August 30, 2021

Product Change Notice - Rivets changed to screws on 08 and DR13 baggage doors

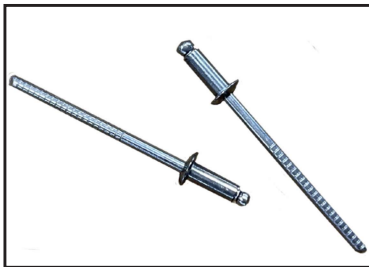
Please be advised Lippert intends to change the fasteners for the panel to the frame from rivets to screws on 08 and DR14 series baggage doors with extruded or piano hinges.

We determined using screws not only makes for a smoother production process, but also creates a more durable product. The screws passed pull testing, slam testing and durability testing. Test results available upon request.

The part number for the current rivet is 255902. The part number for the screw is 338951. There is no change in fit, form, function, installation or operation with the hardware change. The change will begin on a running basis, starting immediately.
